**Re: Response to Draft Comprehensive Zoning By-law 30-25 Amendment  
Report SRPBS.25.090 (City File: MZBA-23-0001)  
48, 50, and 52 Arnold Crescent  
Laurier Homes (Richmond Hill) Inc.**

**APPENDIX 1  
CONCEPTUAL DEVELOPMENT PLANS**

CONCEPTUAL SITE PLAN - SCHEME A SCALE: 1:250

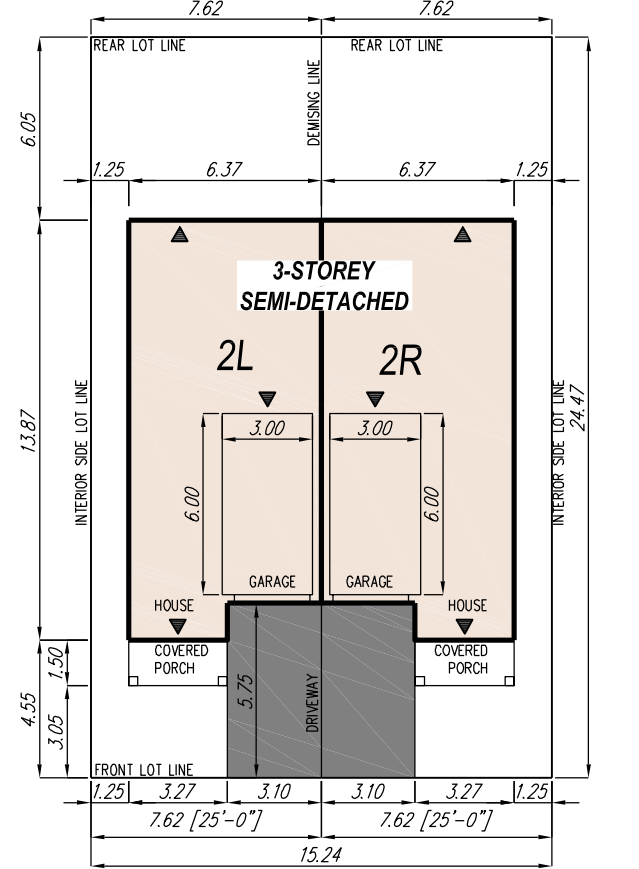
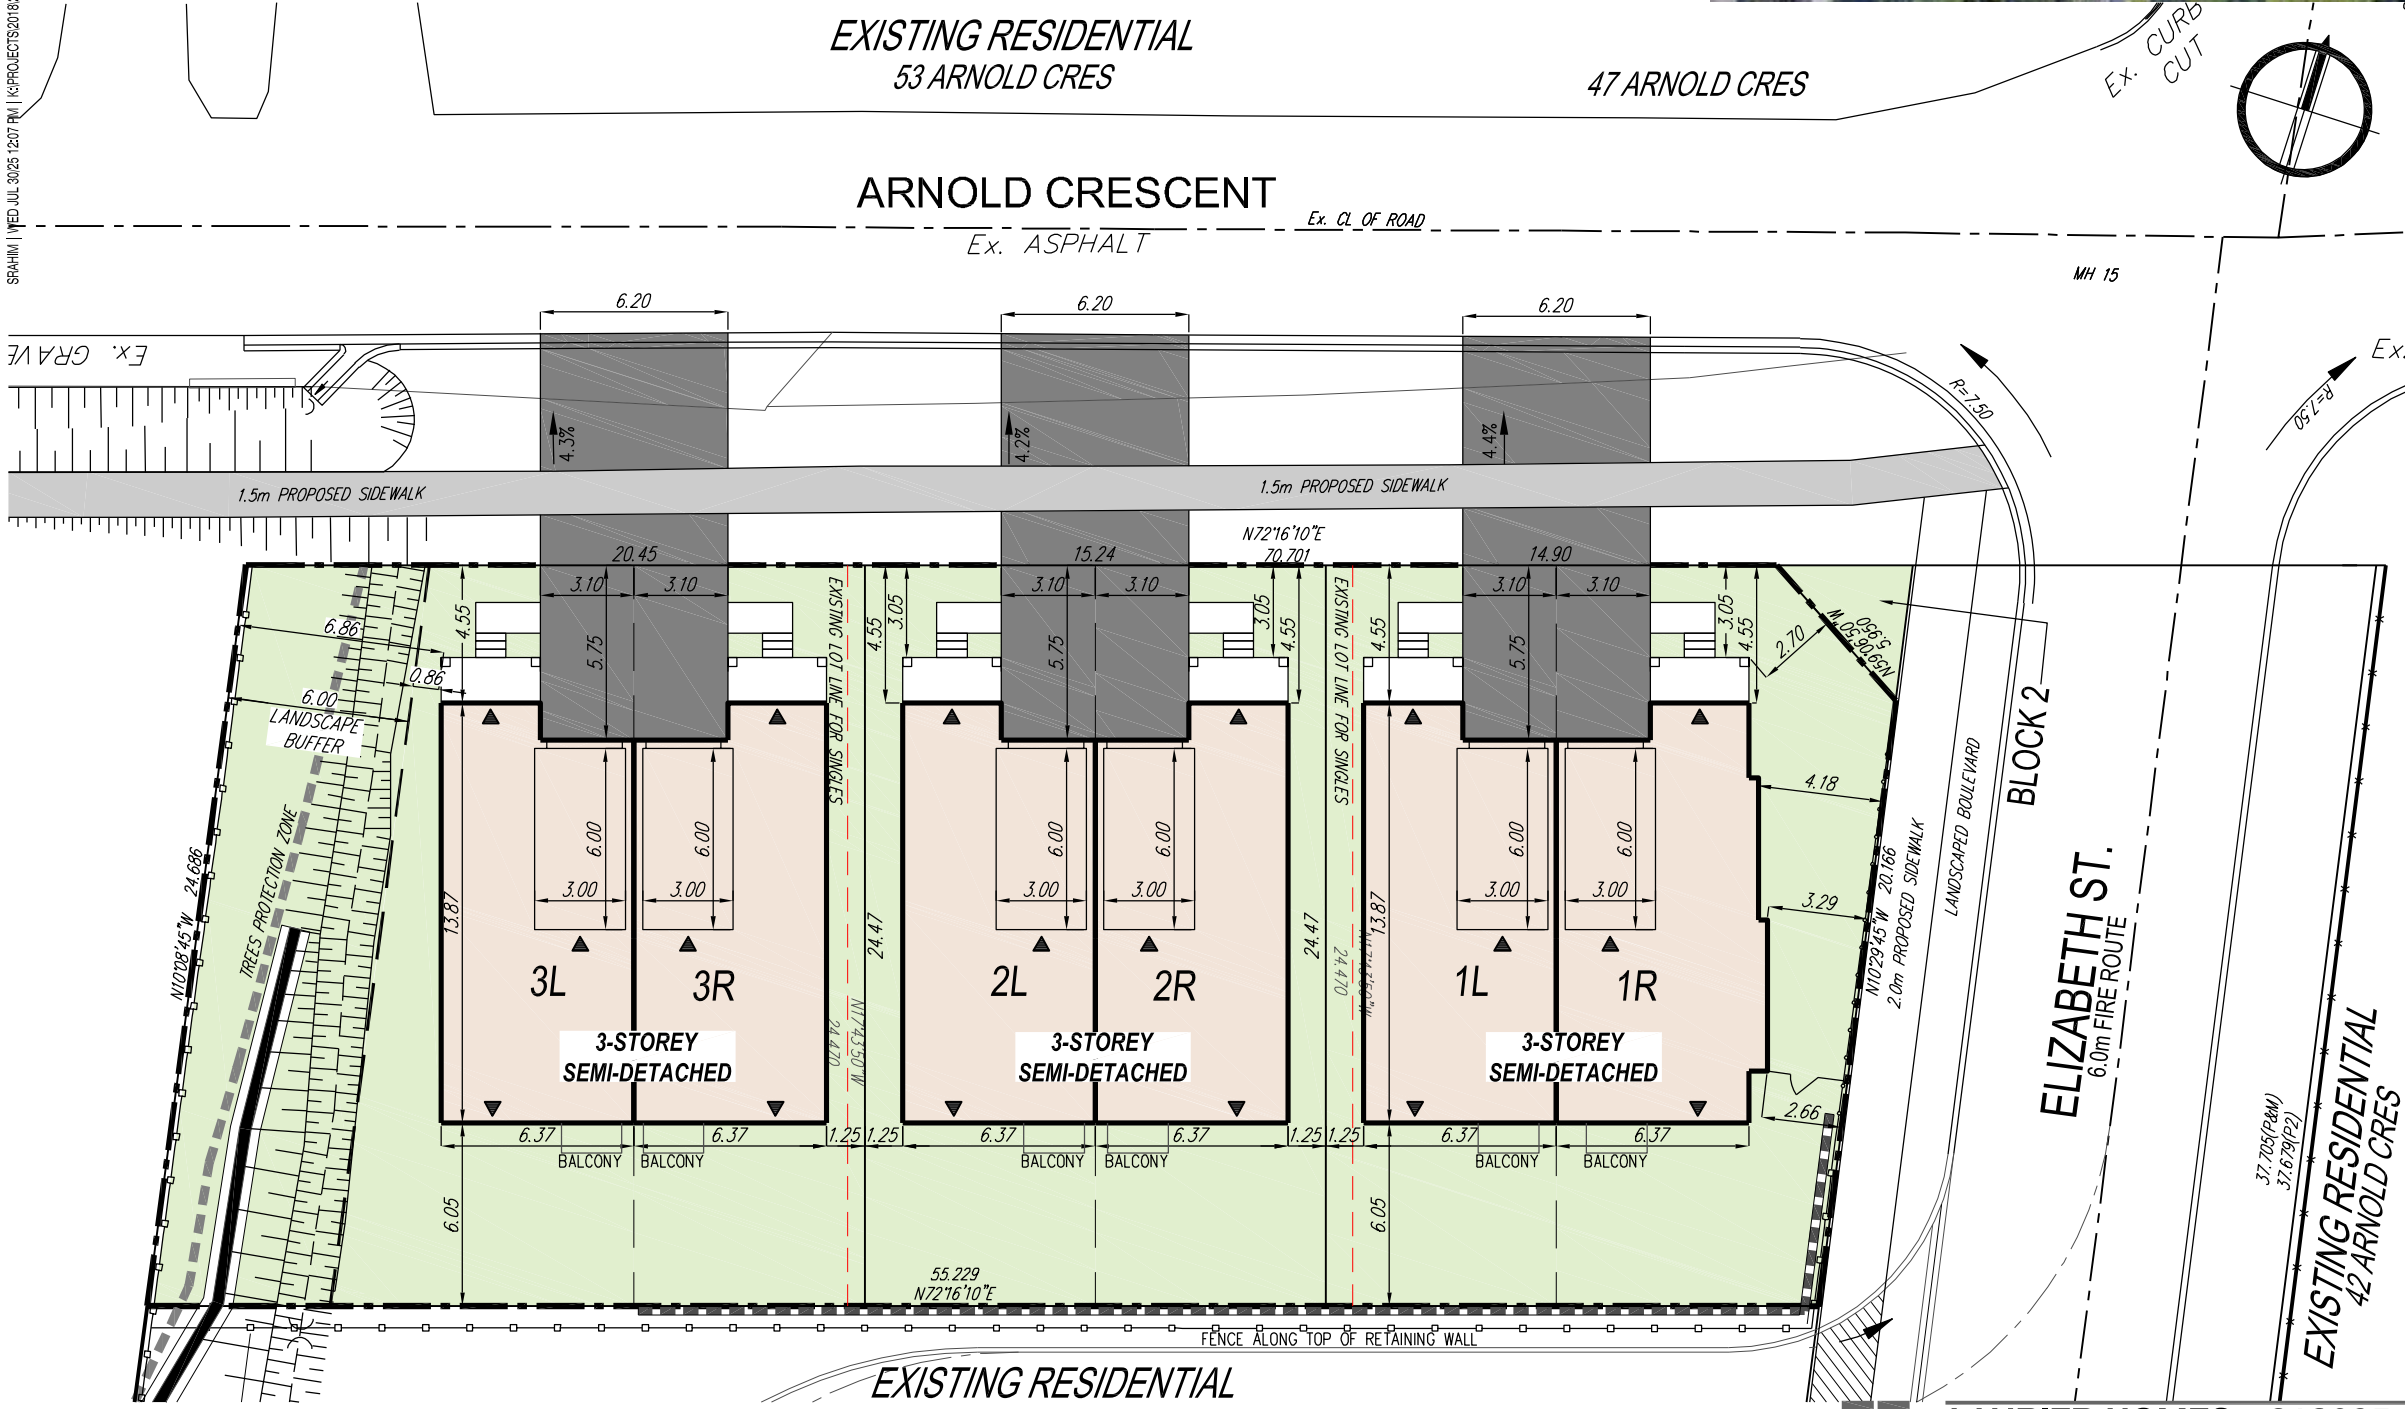
Based on the conceptual site plan, proposed Lot 2 would only achieve a lot area of approximately 373 m<sup>2</sup>, despite providing a lot frontage which greatly exceeds the minimum required within the NS1 Zone, and supporting a dwelling which is otherwise being able to otherwise comply with the CZBL. On this basis, we suggest that it is necessary to reduce the lot area requirement to promote this form of 'soft' intensification within the LC-V Zone while avoiding the need for costly and time consuming Minor Variance Applications.

**FIGURE 1 - SOFT LANDSCAPING CALCULATION**  
 SCALE: 1:250

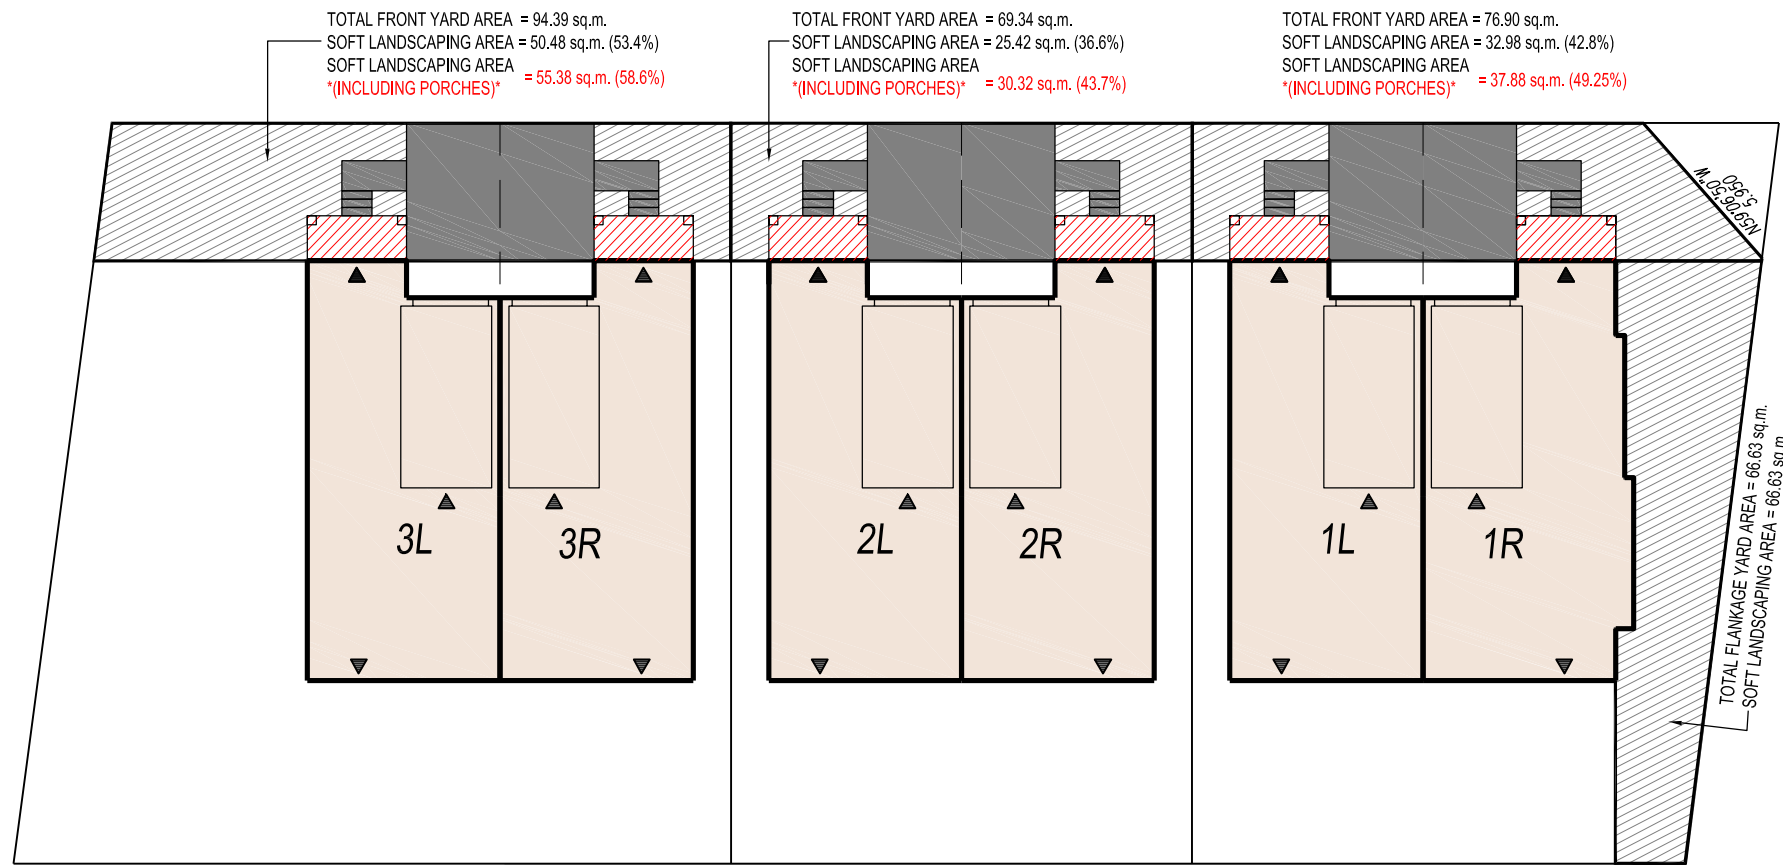
We request clarification as to whether the area of a 'porch' can be included in the calculation of soft landscaping for the purposes of **Regulation 3.6 (b)(i)**. The Regulation provides that *"...the area of the lot covered by the detached accessory structures or **porches** shall be included in the calculation of the minimum **landscaping**" [emphasis added]*. While porches are a permitted encroachment as outlined in **Regulation 3.14**, there is no definition for the term **landscaping** provided in the CZBL which distinguishes whether this area is **hard** or **soft landscaping**.

As shown on the appended plans, this distinction is a significant consideration with respect to the ability to satisfy the required 45% soft landscaping area within the proposed front yards. We also suggest that the requirement should be reduced to 35% as it is clearly demonstrated that a 'regular' building siting configuration still results in difficulty achieving a 45% soft landscaped area, even on lots with buildings that otherwise are able to satisfy the provisions of the CZBL (i.e. larger frontage, greater yard setbacks, and lesser coverage than that required in the CZBL).

**NOTE:**  
 NEED CONFIRMATION FROM ZONING DEPARTMENT IF COVERED PORCHES CAN BE INCLUDED IN THE CALCULATION OF "SOFT" LANDSCAPING

**FIGURE 2 - CONCEPTUAL CROSS SECTION**  
 SCALE: NTS

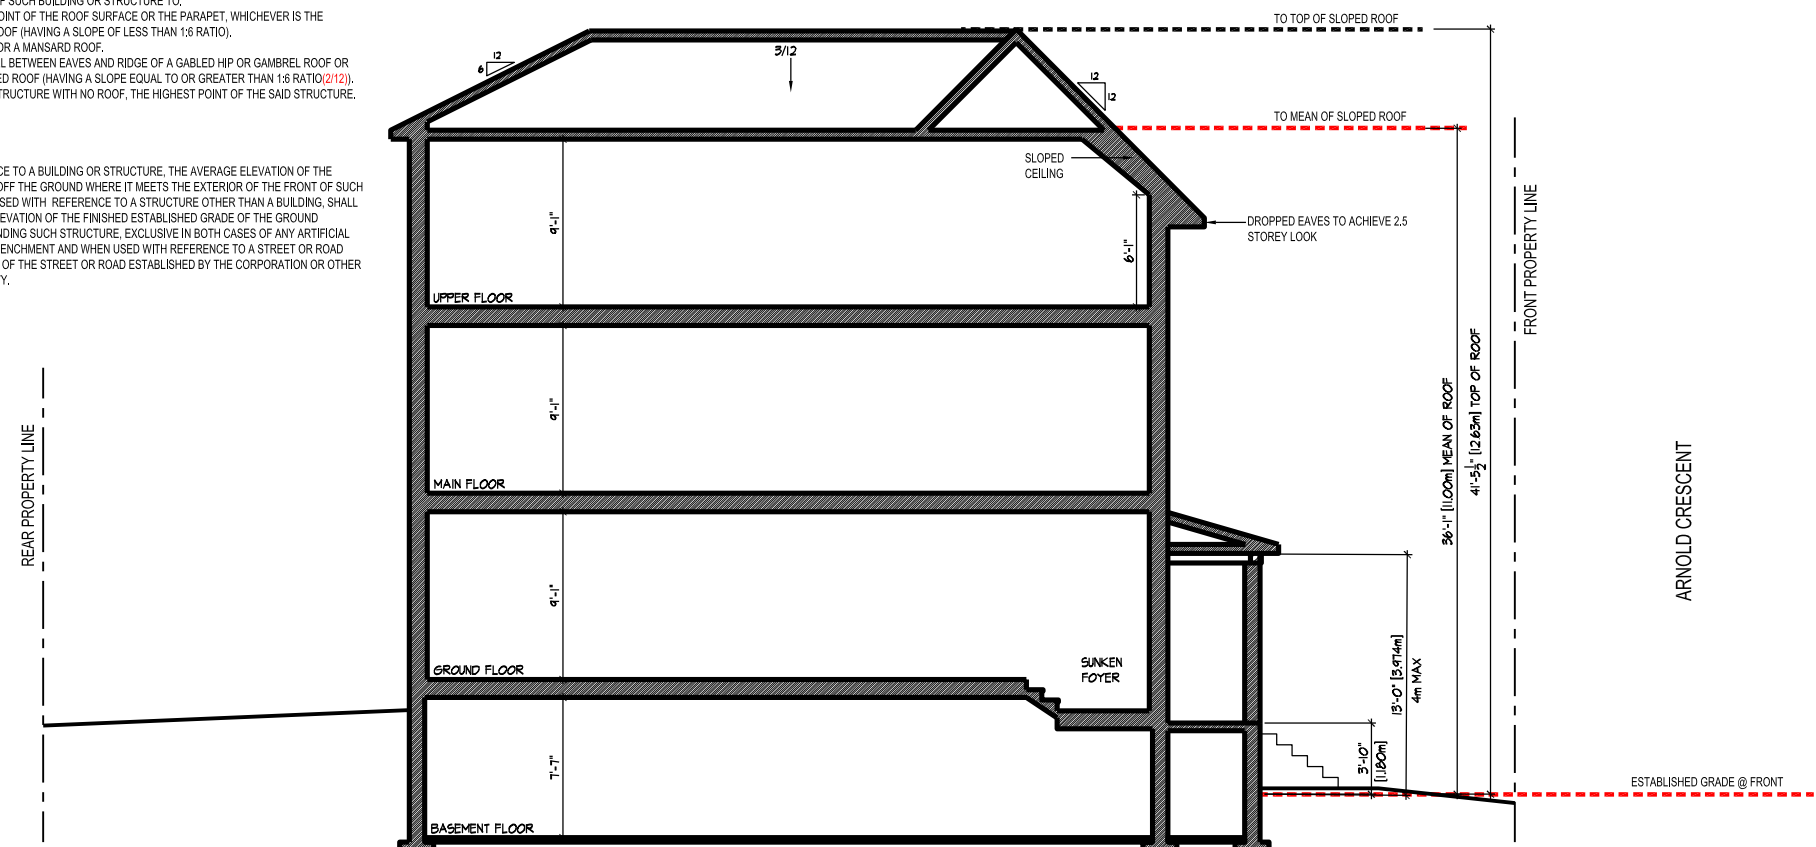
Further, as shown on the attached conceptual cross section, while the proposed dwellings are potentially able to satisfy the height requirements, there is little room for flexibility based on grading conditions and current market desires for internal living arrangements. In this regard, we suggest that consideration should be given to increasing the maximum height to 12 metres.
